[Darshan_04_0917.pdf](#) (PSE state machine Part A- Using CLASS_PROBE in Figure 145-15/16)

Comment (i-198, i-269, i-406)

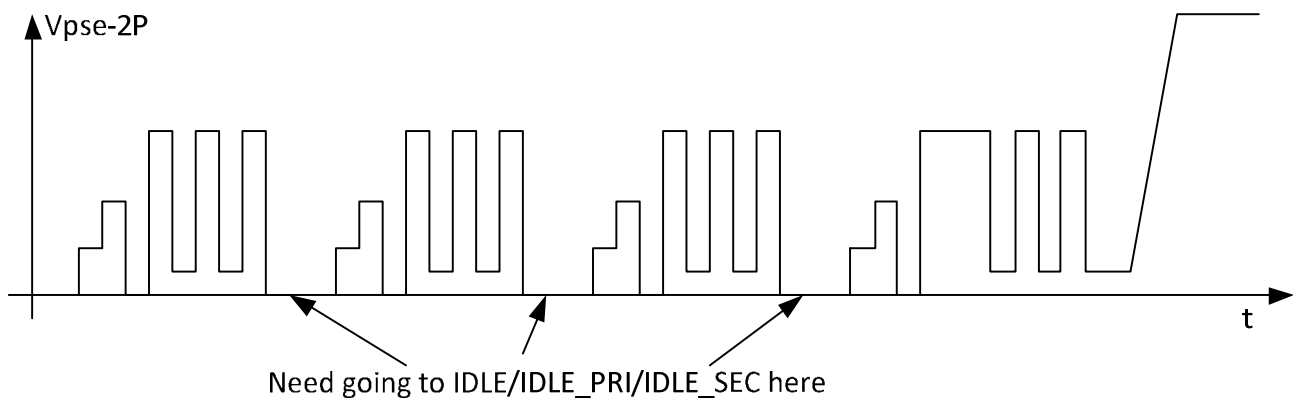
Some PSE architectures are generating sequences of detection + classification events and waiting for the host to decide when to power on the port. This requires the class probe functionality and exit to IDLE in the classification state machines (for single-signature and dual-signature). Single-signature has global pse_reset input to IDLE so in this case, PSE can go to IDLE at any time. It is not the case in dual-signature.

- (1) Add CLASS_PROBE_PRI/SEC functionality for primary and secondary.
- (2) Add global exit to IDLE_PRI/SEC by using pse_reset_pri/sec by changing the input to IDLE_PRI to $\text{sism}^*(\text{iclass_lim_det_pri} + \text{pse_reset_pri})$ it will do two things: pse_reset_pri and multi-true issue with IDLE_PRI and ENTRY_PRI. To implement same changes for secondary.

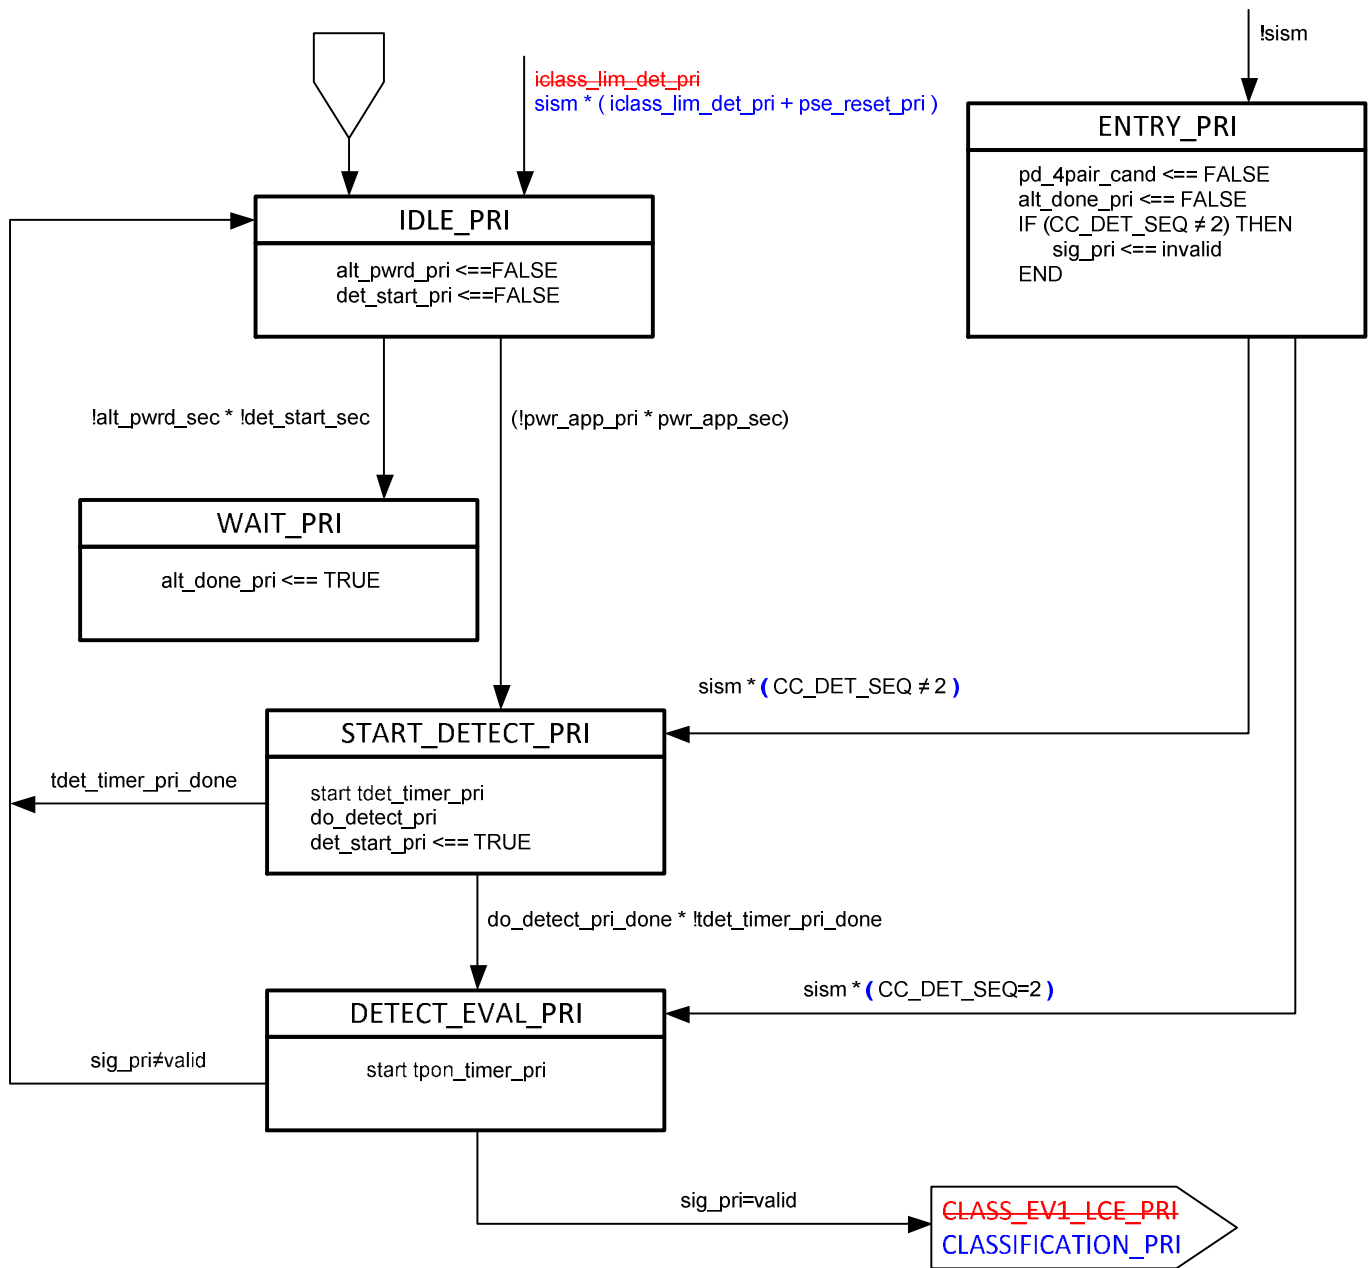
3. Make the following changes to the state machine in page 132

Figure 145-15—Primary Alternative dual-signature semi-independent PSE state diagram (continued)

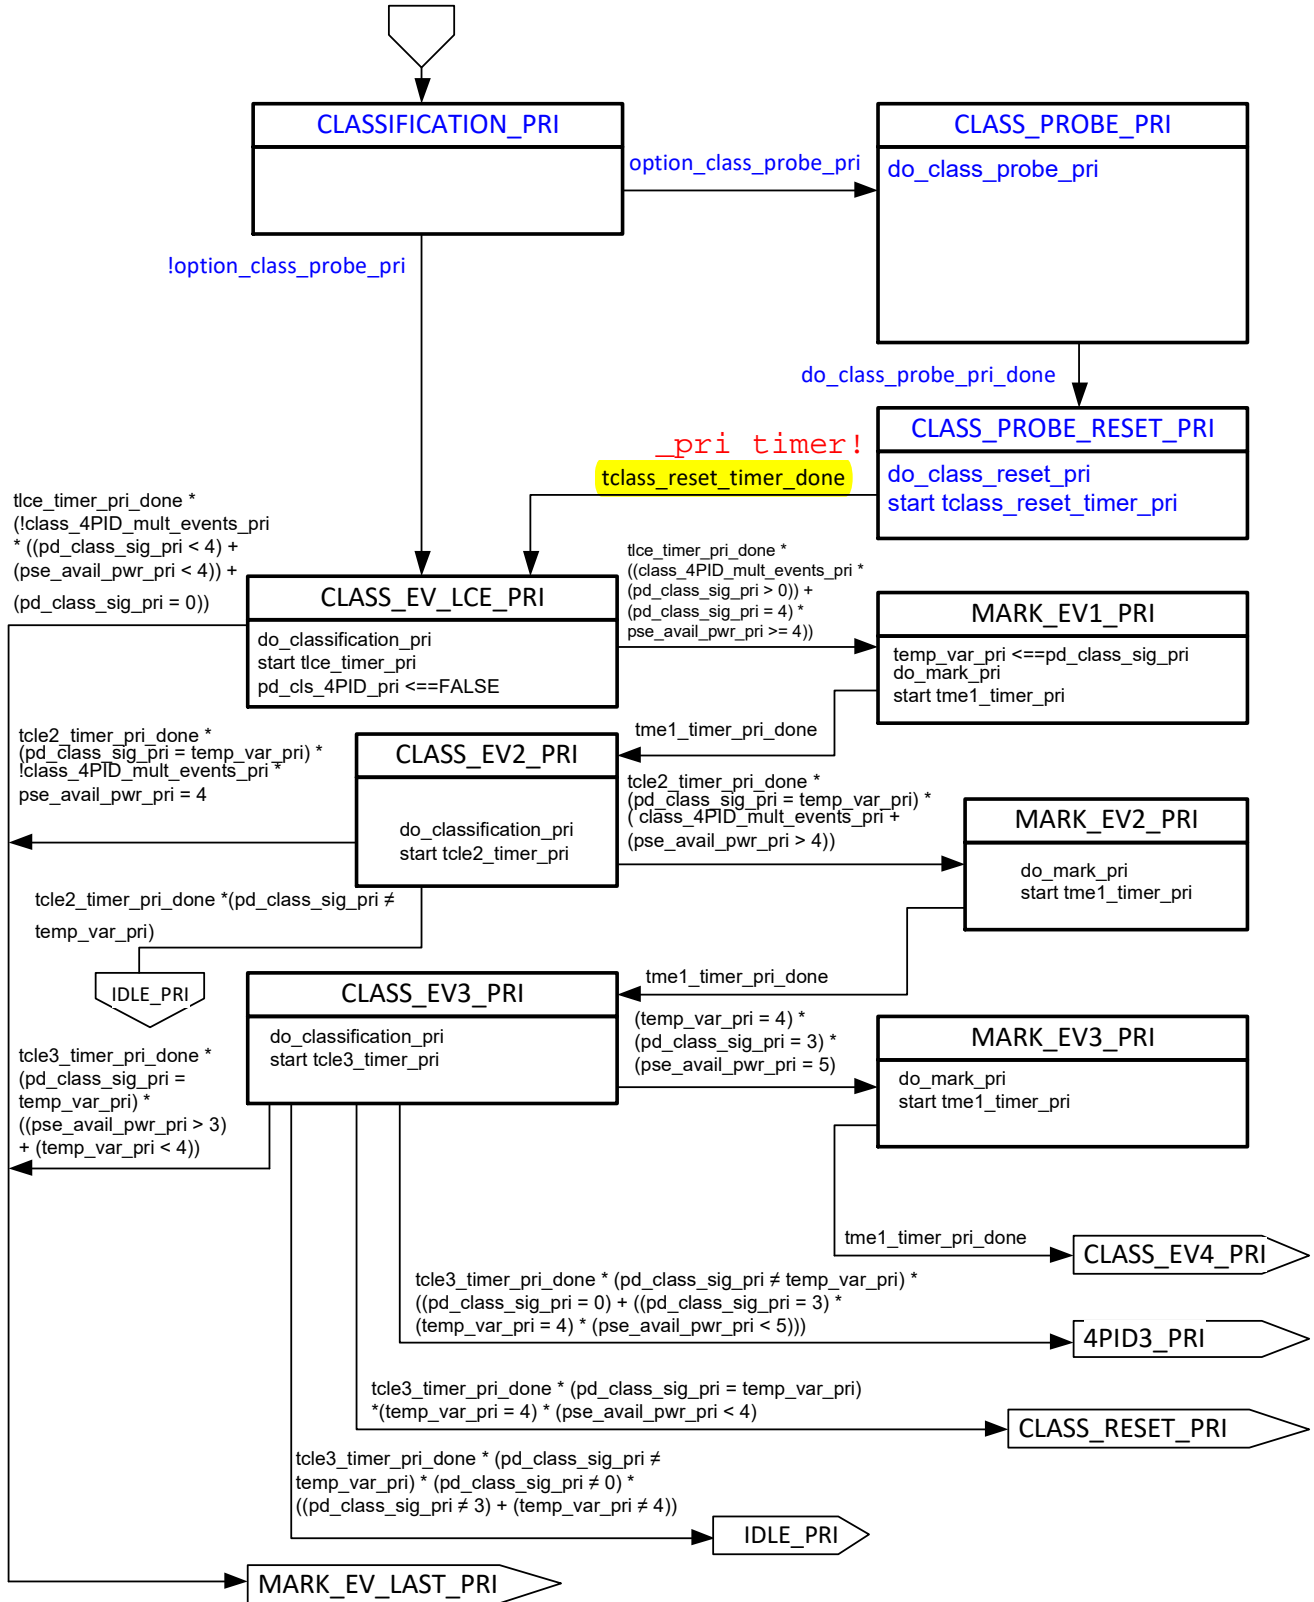
4. Make the following changes to Figure 145-15 page 133

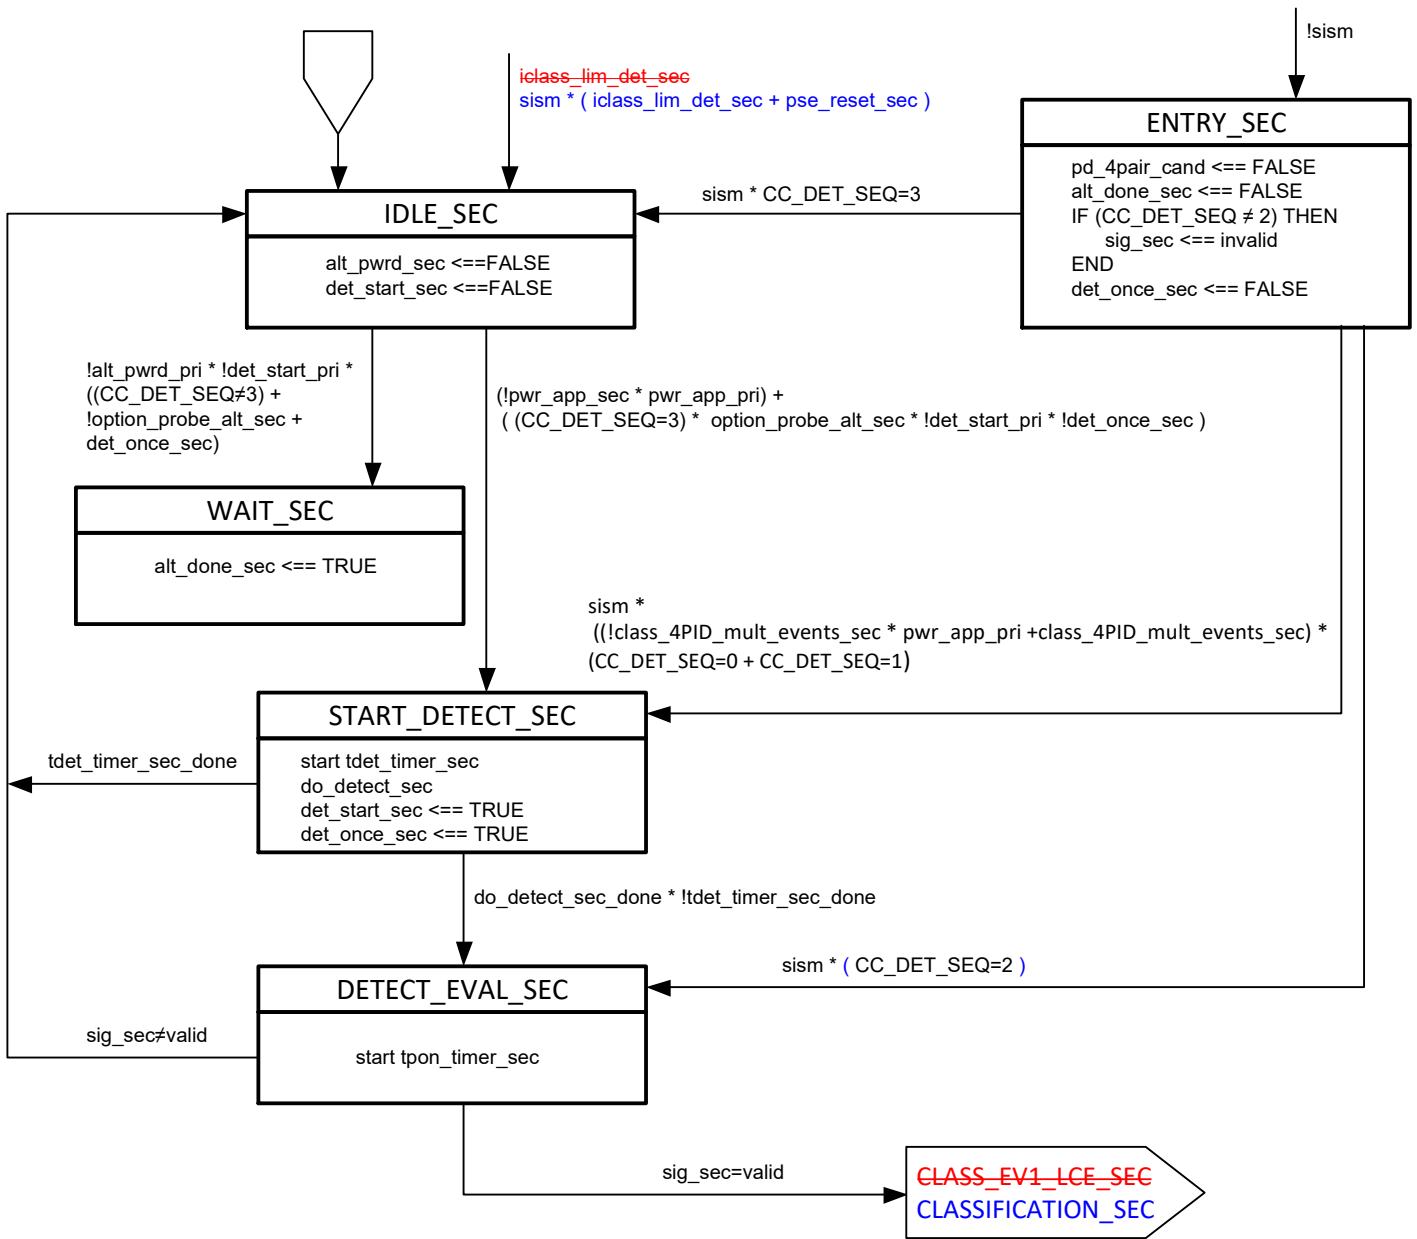
5. Make the following changes to the state machine in page 136

Figure 145-15—Primary Alternative dual-signature semi-independent PSE state diagram (continued)

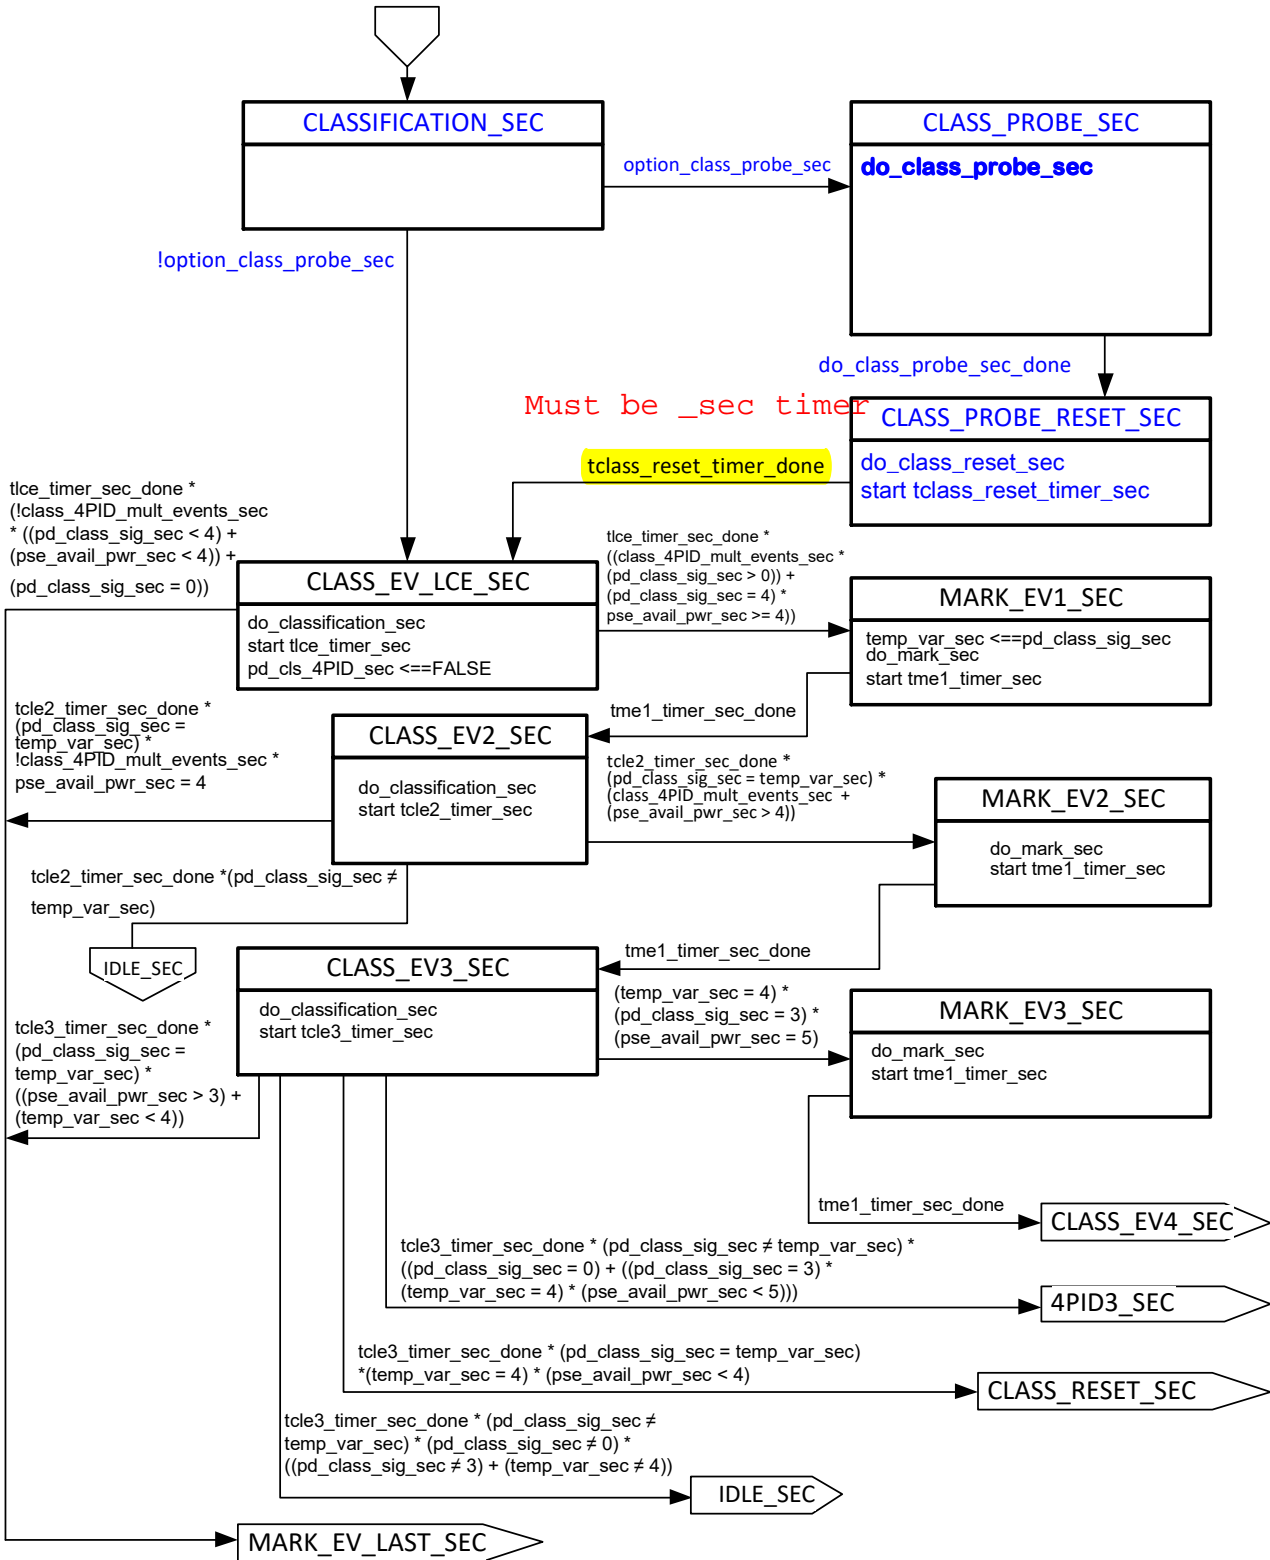
6. Make the following changes to Figure 145-15 pages 137
